# Beechcraft

# SERVICE INSTRUCTIONS

No. 1218  
ATA Code 32-20

- SUBJECT:** LANDING GEAR - REPLACEMENT OF THE NOSE LANDING GEAR ATTACHMENT BOLTS.
- EFFECTIVITY:** BEEHCRAFT Skipper 77, serials WA-1 through WA-312.
- REASON:** To improve the structural integrity of the nose landing gear attachment points.
- COMPLIANCE:** Beech Aircraft Corporation considers this to be a mandatory modification and it should be accomplished as soon as possible after receipt of these Service Instructions, but no later than the next 50 service hours.
- APPROVAL:** Engineering data contained in these Service Instructions is FAA approved.
- MANPOWER:** The following information is for planning purposes only:

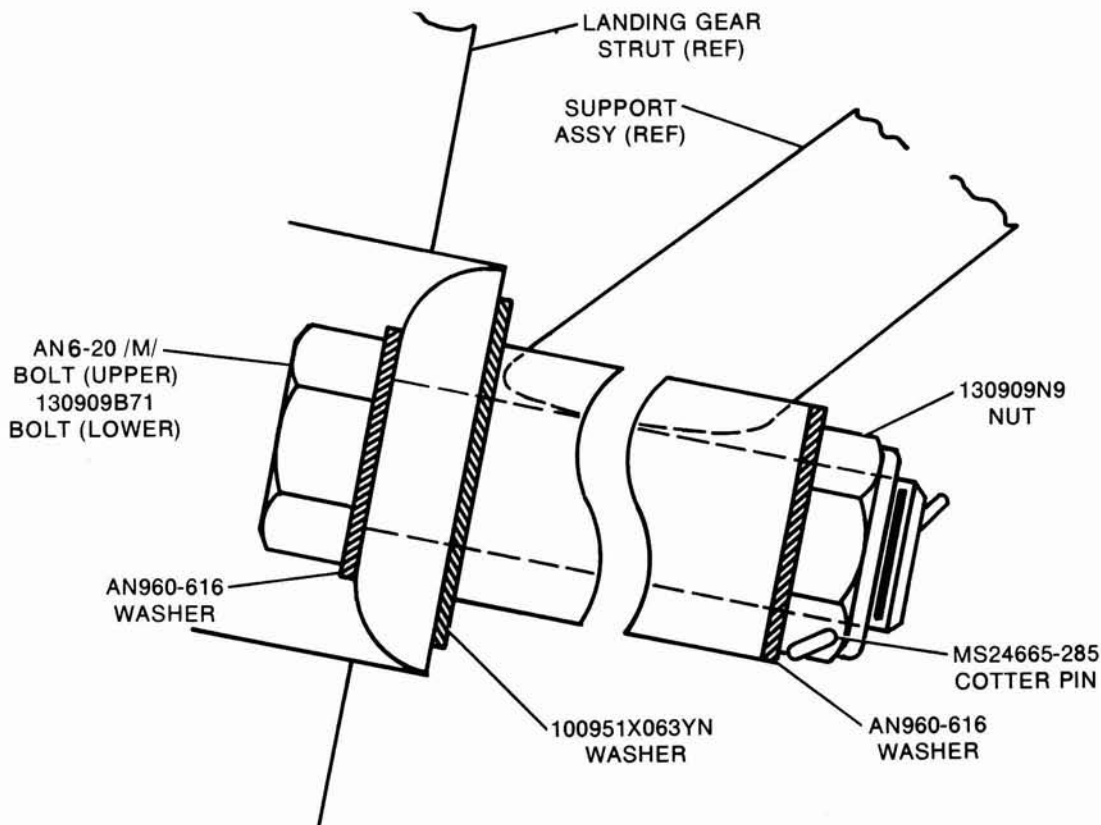
4. Reinstall the nose landing gear using AN6-20 /M/

bolts in the two upper mounting holes and 130909B71 bolts in the lower mounting holes. Install the bolts, washers, and nuts as shown in the illustration. Bolts may be installed with the head forward or aft, as required, for torquing.

5. Torque the nuts to 150-190 inch-pounds and install the MS24665-285 cotter pins. Do not back off torque on the nuts to install the cotter pins. The nuts may be torqued to 390 inch-pounds for cotter pin hole alignment. If the cotter pin holes cannot be aligned within these tolerances, repeat the torquing procedure, using new 130909N9 nuts.
